**CITY OF BATON ROUGE
PARISH OF EAST BATON ROUGE
DEPARTMENT OF PUBLIC WORKS
SEWER ENGINEERING DIVISION**

ADDENDUM NO. 4

SUBJECT: FLORIDA BOULEVARD PUMP STATION IMPROVEMENTS
CITY-PARISH PROJECT NO. 11-PS-MS-0003

STANDARD PLAN NO. 804-01	DATED AUGUST 1, 2011	SHEET NO. 1 OF 3
-----------------------------	-------------------------	---------------------

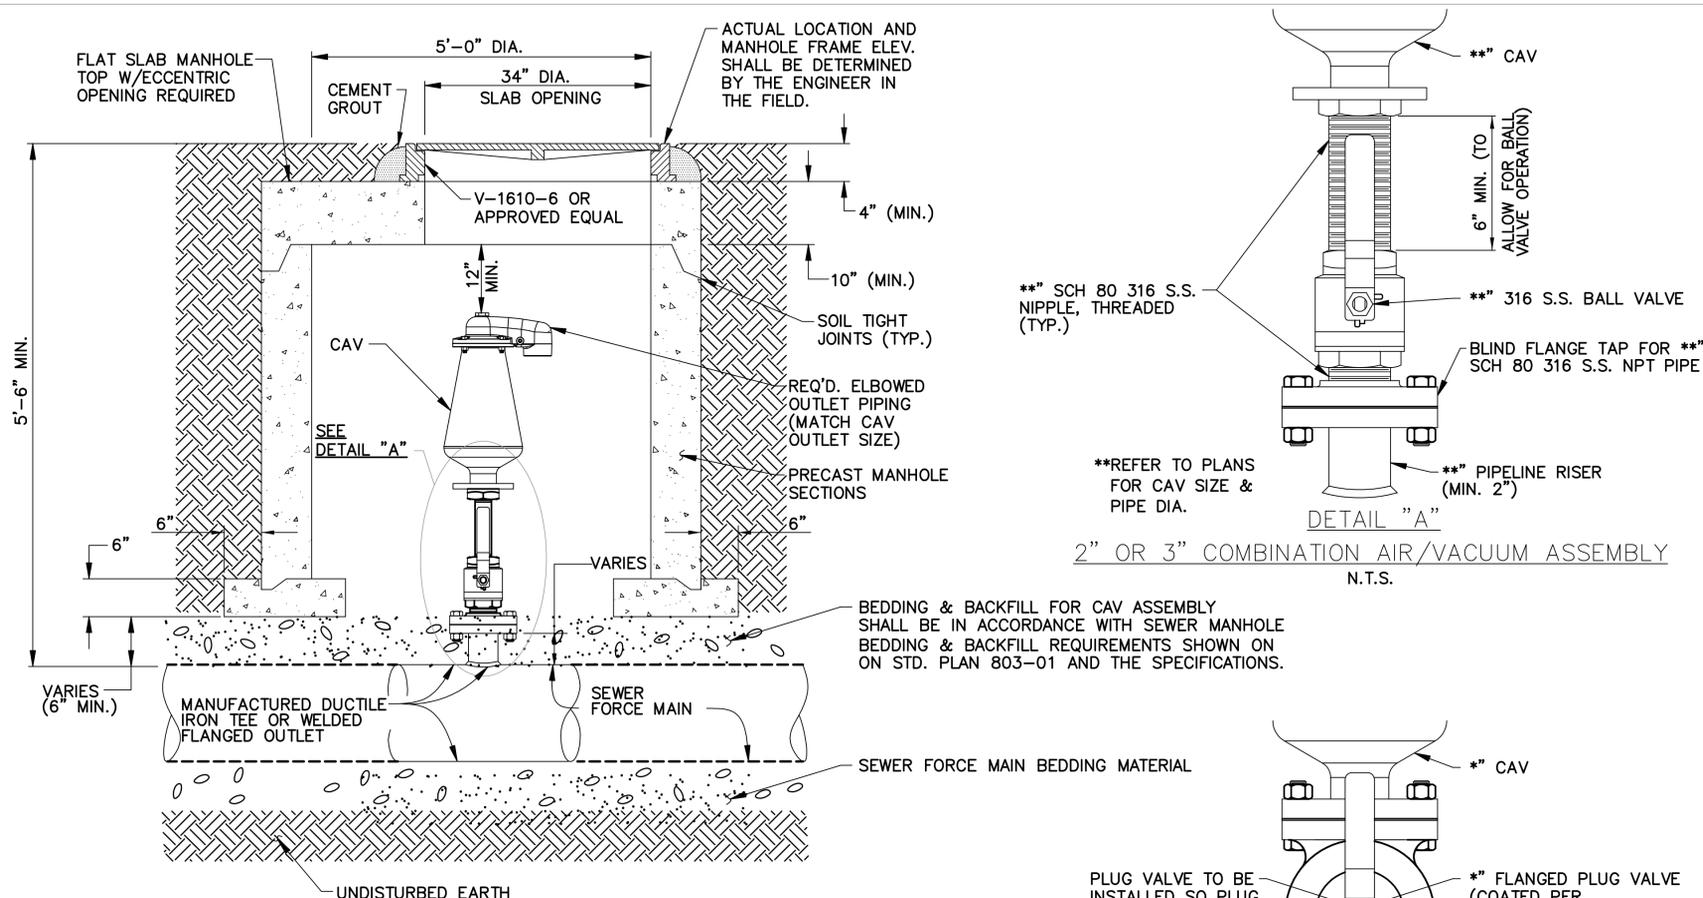
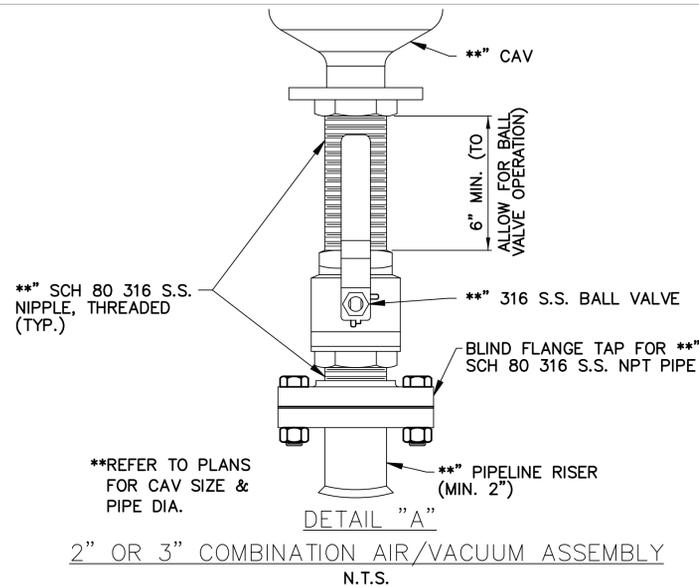
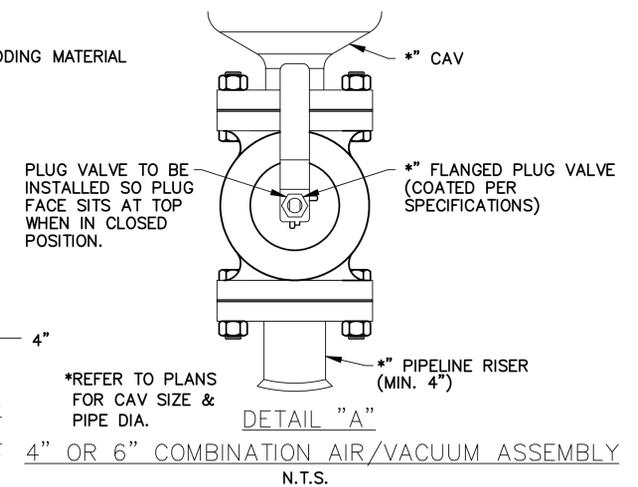
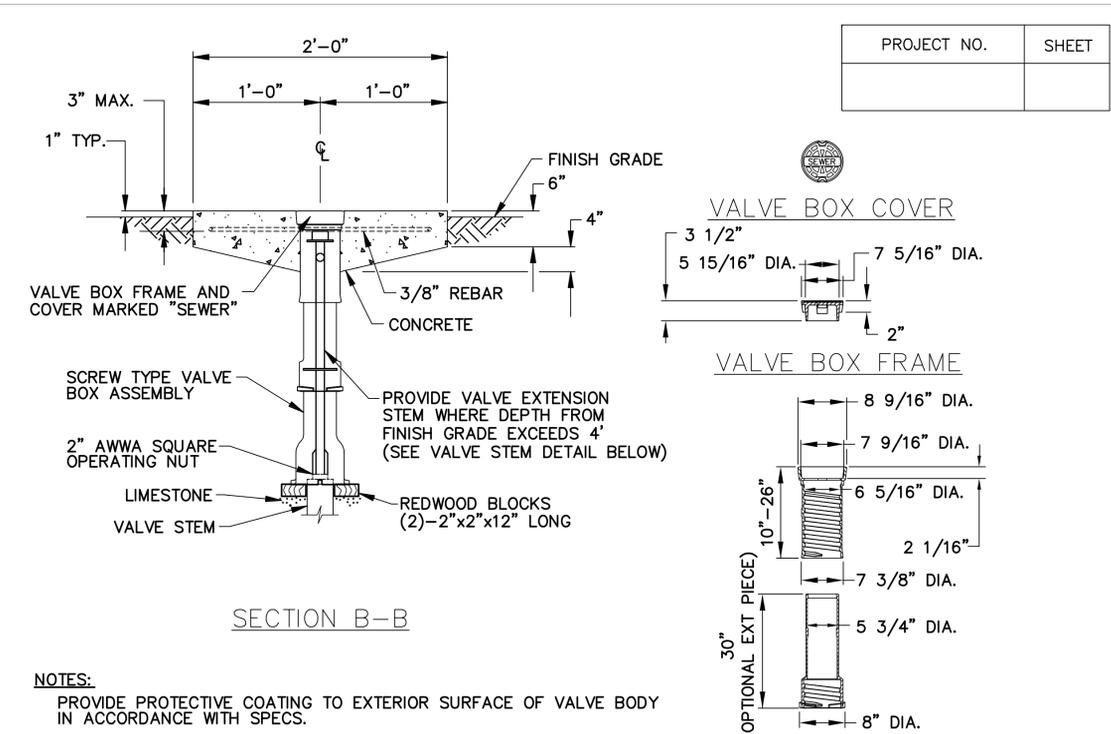
10. Delete EBR Parish Standard Plan No. 803-01 (1 of 3) and Replace with attached Revised EBR Parish Standard Plan No. 803-01 (1 of 3).
11. Delete EBR Parish Standard Plan No. 804-01 (1 of 2) and Replace with attached Revised EBR Parish Standard Plan No. 804-01 (1 of 3).

2. **Per this addendum, Standard Plan No. 804-01 (1 of 2) has been replaced with Standard Plan No. 804-01 (1 of 3). Standard Plan No. 804-01 (3 of 3) is not required for this project.**
3. SP 9-5.2, there are many items discussed, but where is this work shown or drawn on the bid documents? All of these items referenced should be shown on the bid documents.

STANDARD PLAN NO. 805-02	DATED JULY 12, 2013	SHEET NO. 1 OF 2
-----------------------------	------------------------	---------------------

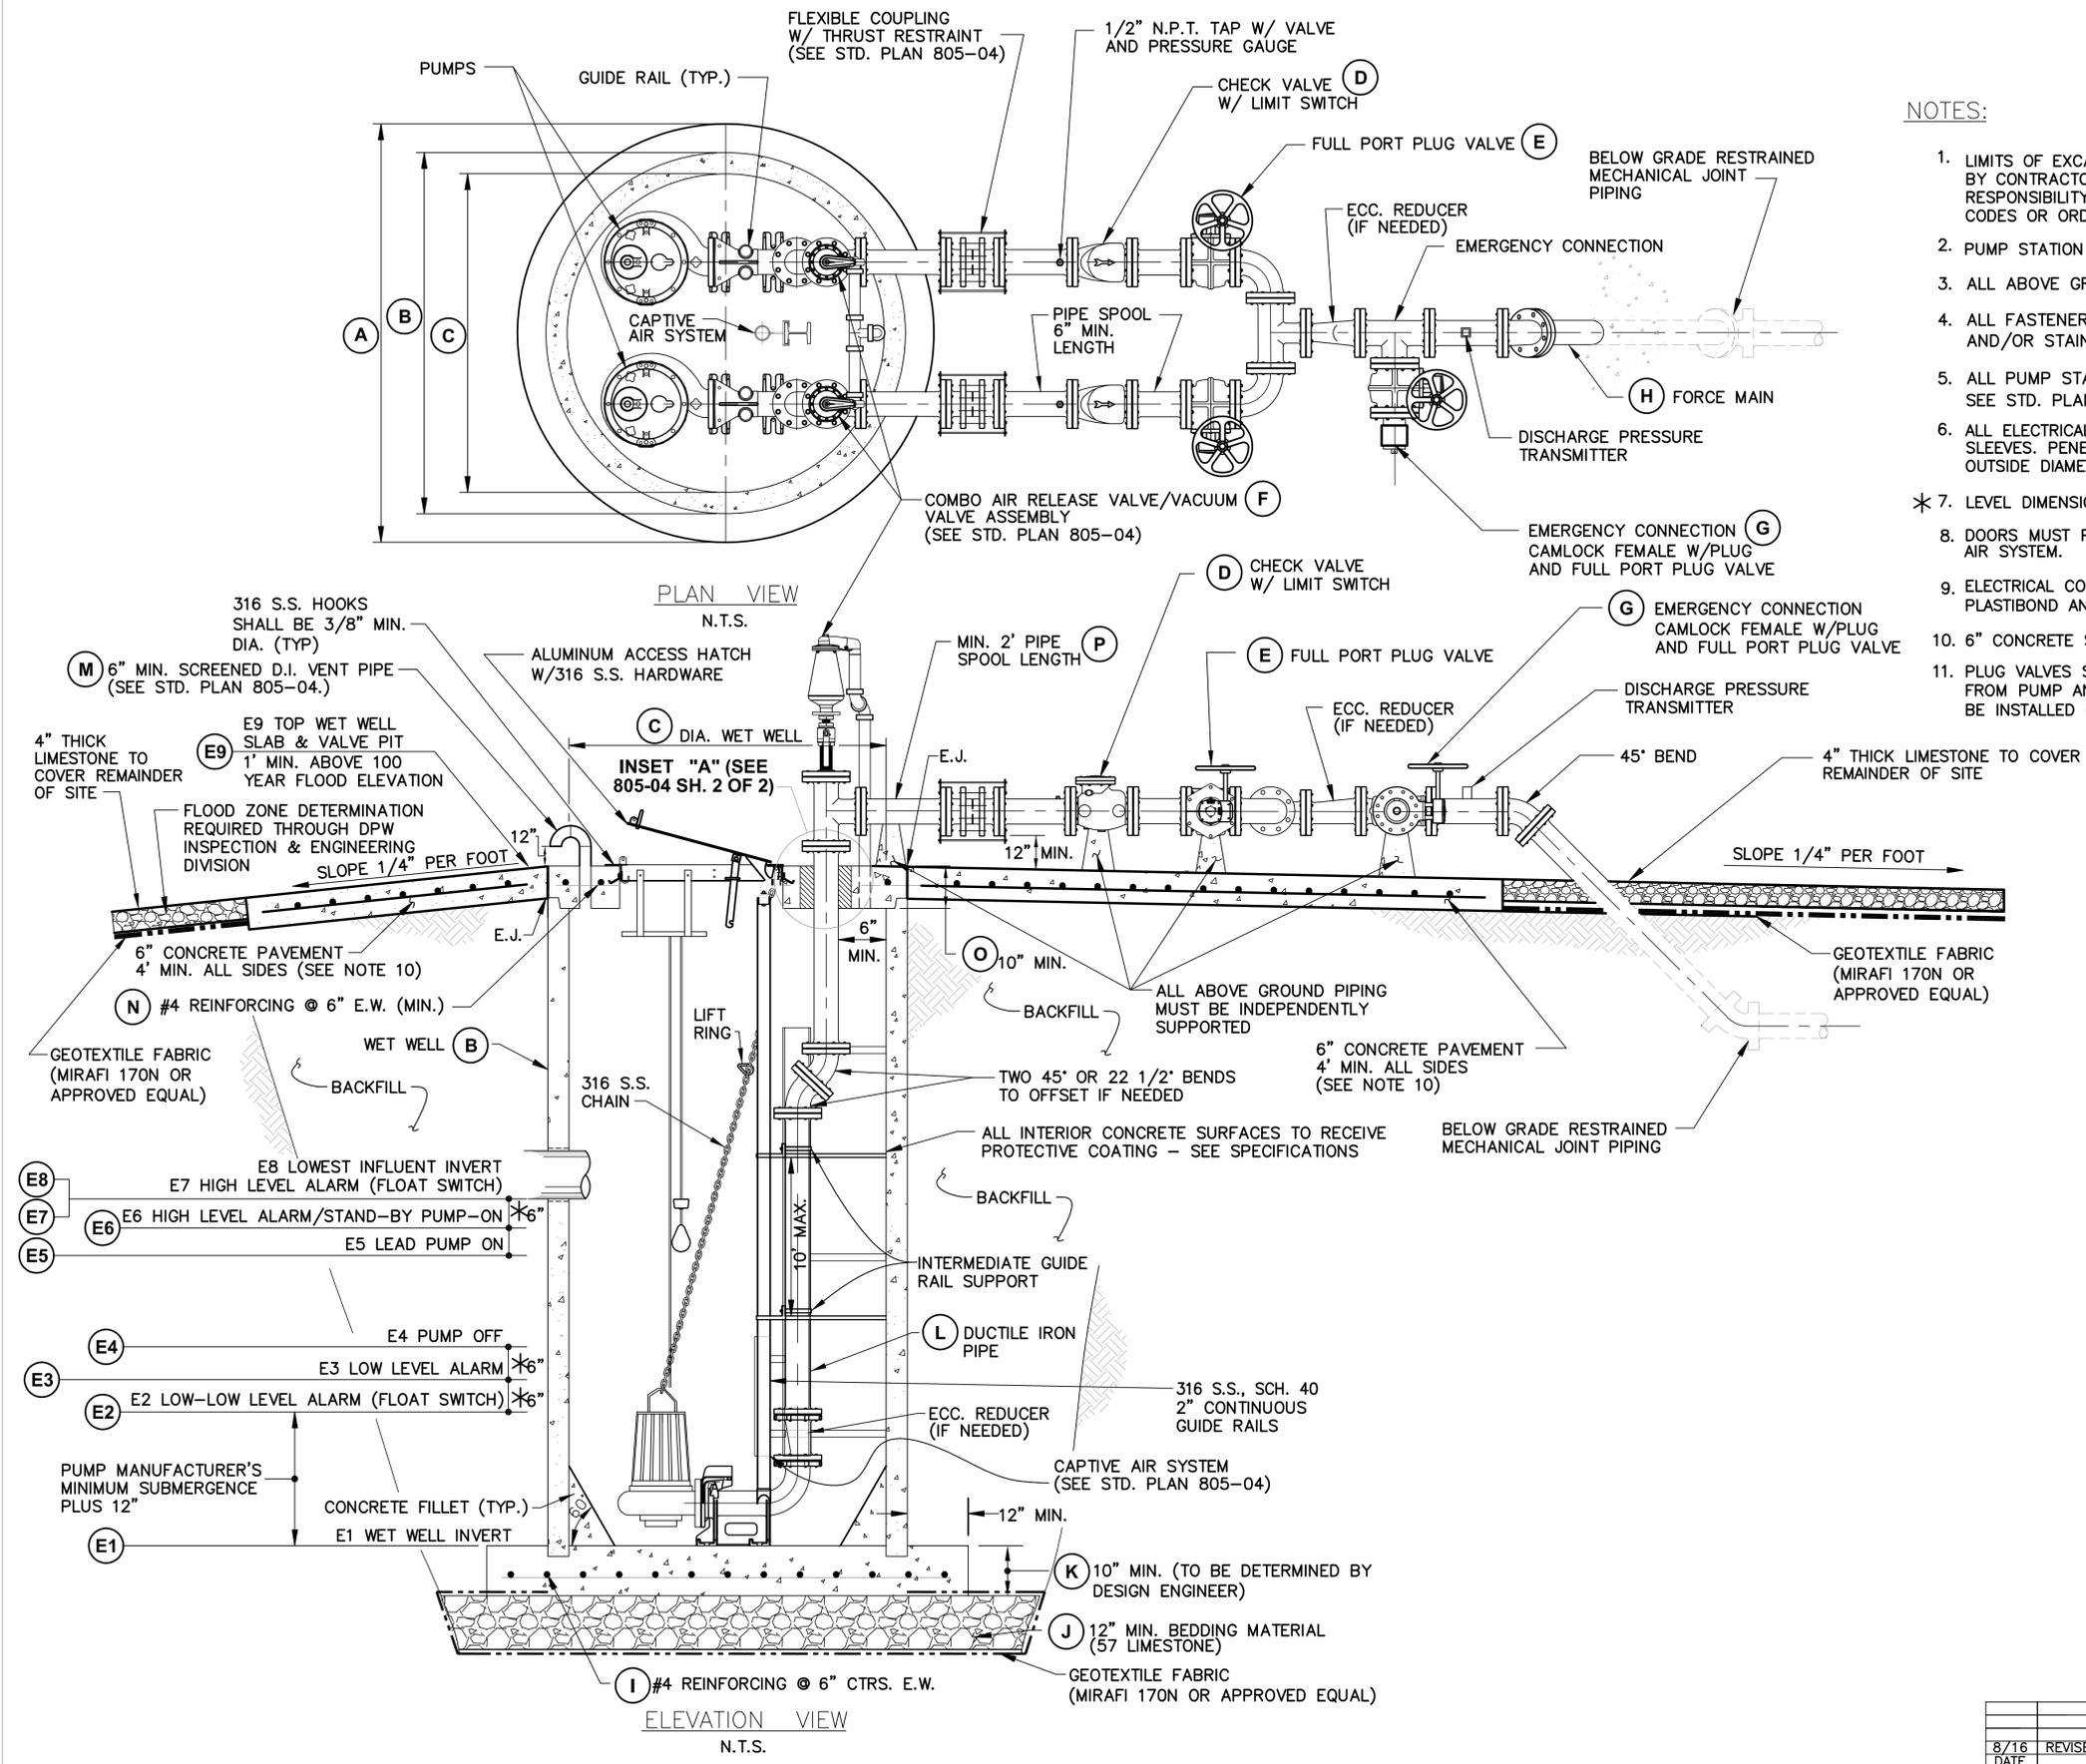
5. Delete Sheets 16-M-01, 18-M-01, 66-M-01, 101-M-01, 151-M-01, and Replace with the attached Revised EBR Parish Standard Plan No. 805-02 (1 of 2).
6. Sheets 16-M-02, 18-M-02, 21-M-02, 66-M-02, 101-M-02, and 151-M-02, in Dimensions Table, Delete "E – Gate Valve" and Replace with "E – Plug Valve".

1. **Contractors shall note revised requirements for combination air release/vacuum relief valve (CARVs) assemblies as shown on Revised Standard Plan No. 805-02 and 805-03. As indicated, CARVs shall be provided atop the vertical riser pipe for each pump at each duplex/triplex station as shown on the revised standard drawings. For duplex stations PS 16, PS 18 and PS 151, CARV installations shall also be provided on the common discharge piping (above-grade) as shown on the original Standard Plans No. 805-02 and 805-03. For all other duplex and triplex stations, the Revised Standard Plan No. 805-02 and 805-03 shall govern. See Table 1 below for a tabulation of CARVs for all duplex/triplex stations."**

8/16	REVISED VARIOUS VALVE & PIPING DETAILS	AMS
DATE	DESCRIPTION	BY
	REVISIONS

STANDARD PLAN NO. 805-03	DATED JULY 12, 2013	SHEET NO. 1 OF 2
-----------------------------	------------------------	---------------------

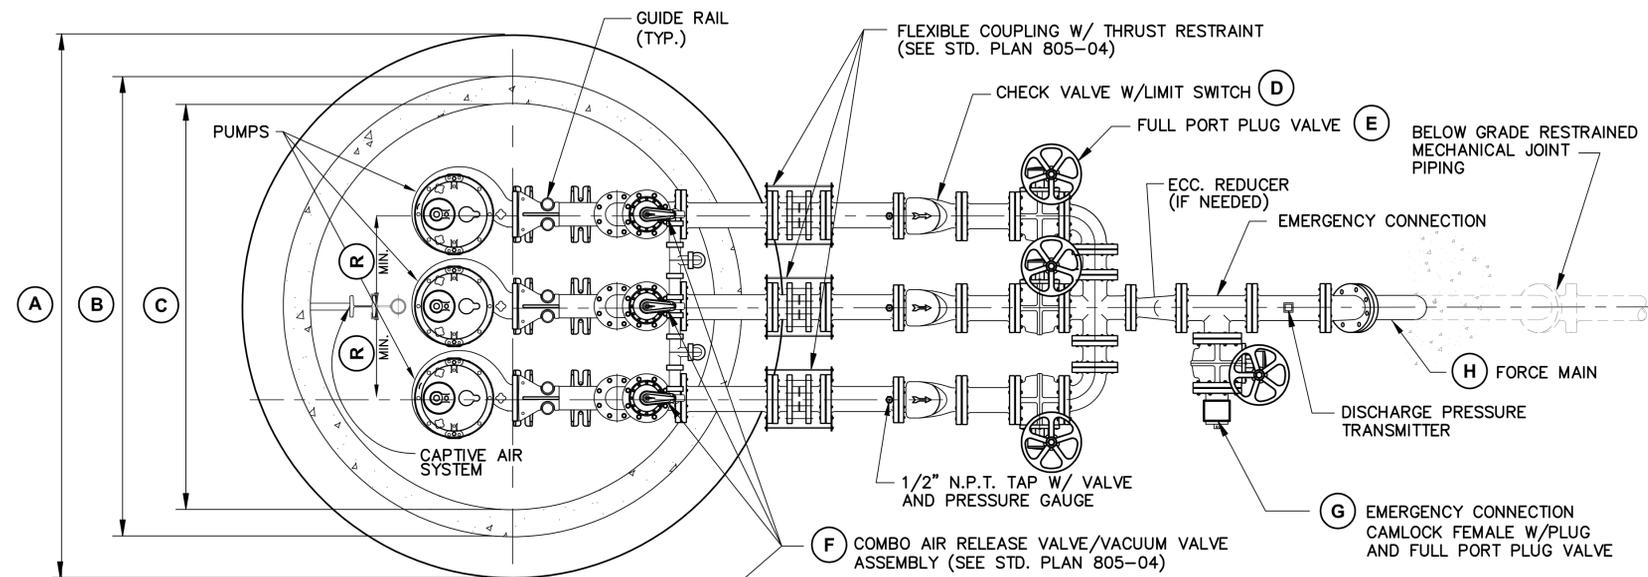
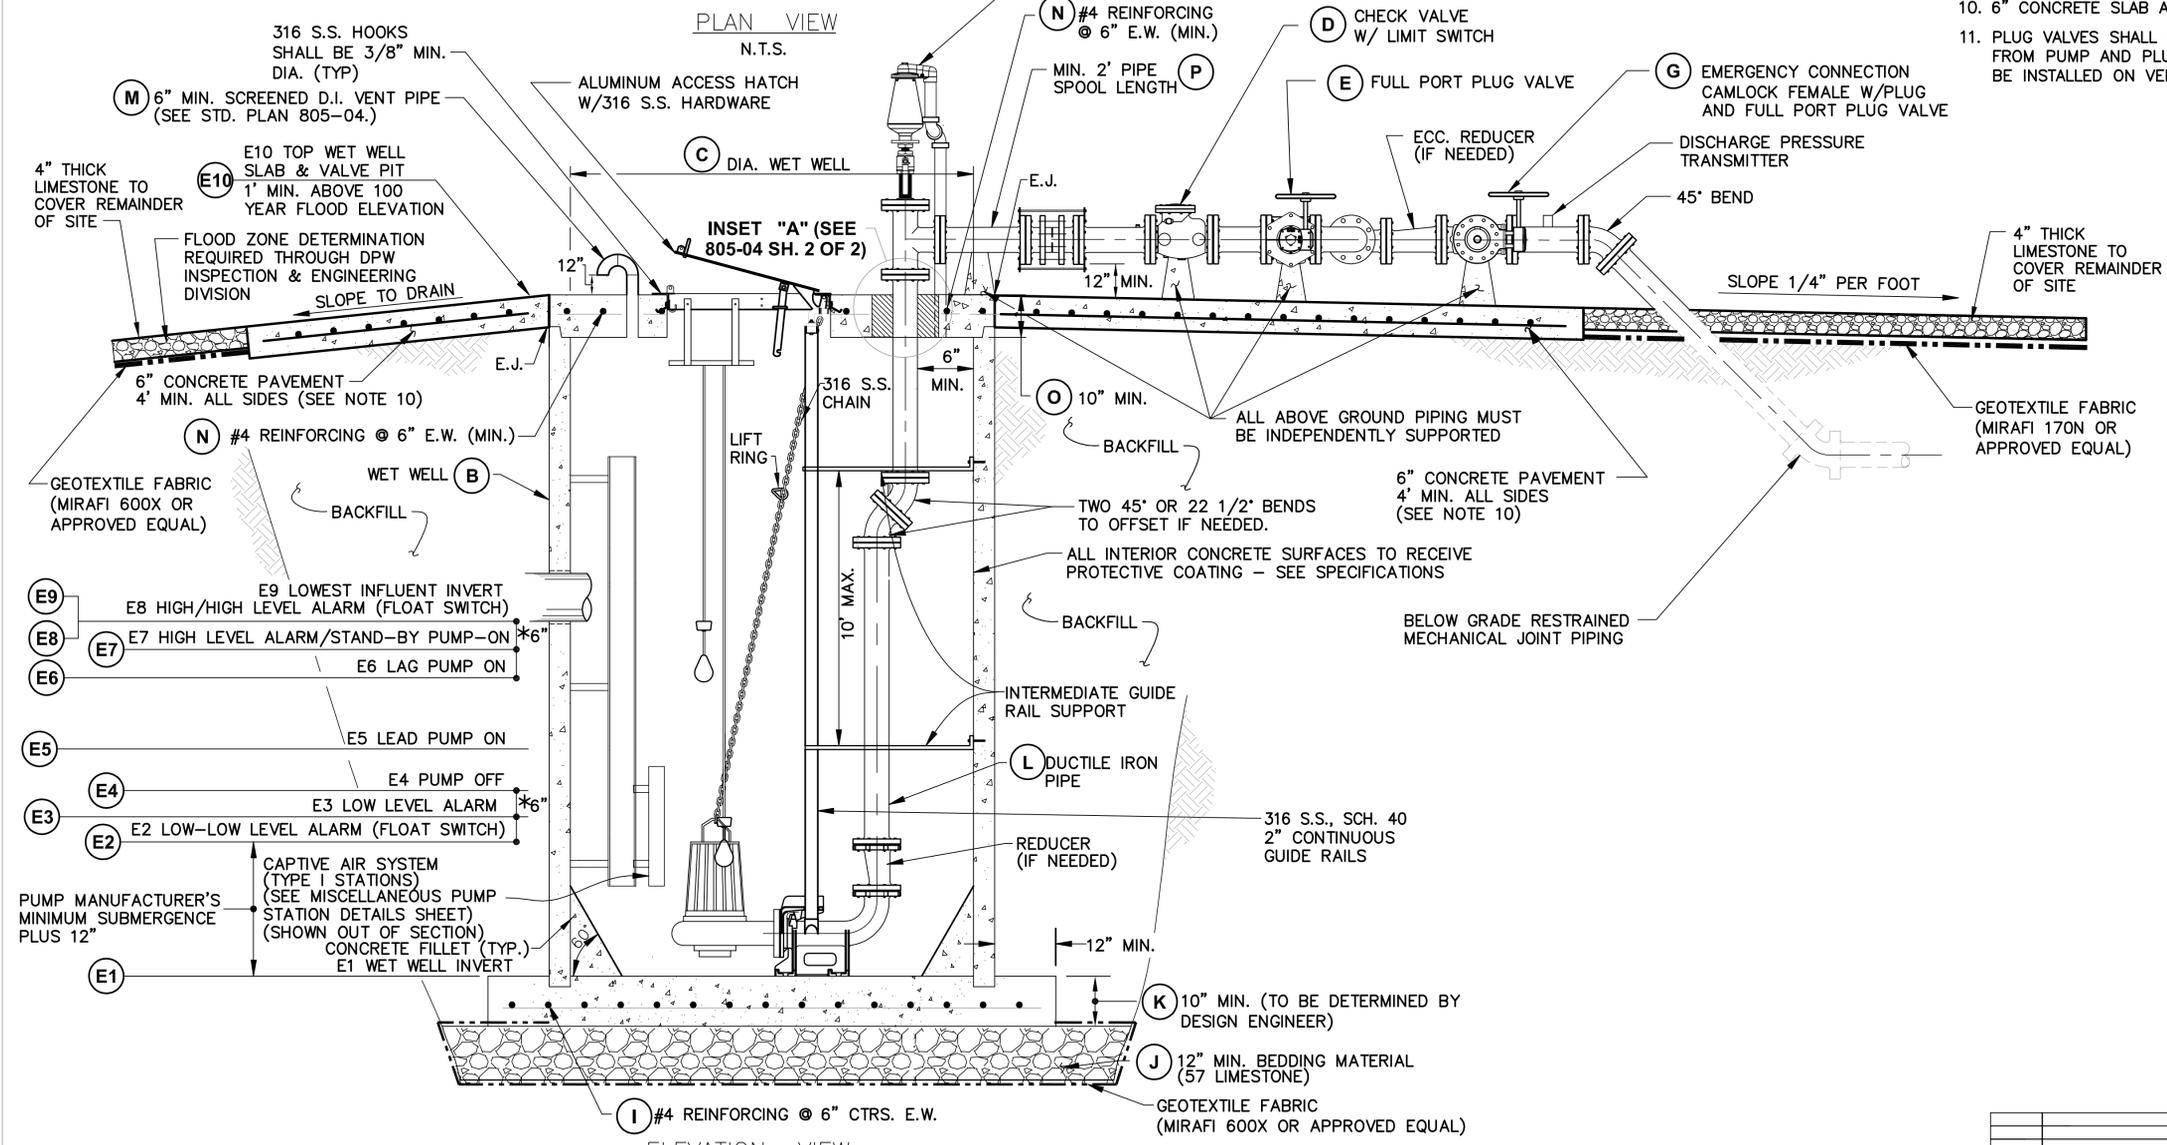
7. Delete Sheet 21-M-01 and Replace with the attached Revised EBR Parish Standard Plan No. 805-03 (1 of 2).
8. Delete EBR Parish Standard Plan No. 801-01 and Replace with attached Revised EBR Parish Standard Plan No. 801-01.

DATE	DESCRIPTION	AMSBY
8/16	REVISED VARIOUS VALVE & PIPING DETAILS	AMS
	REVISIONS	BY
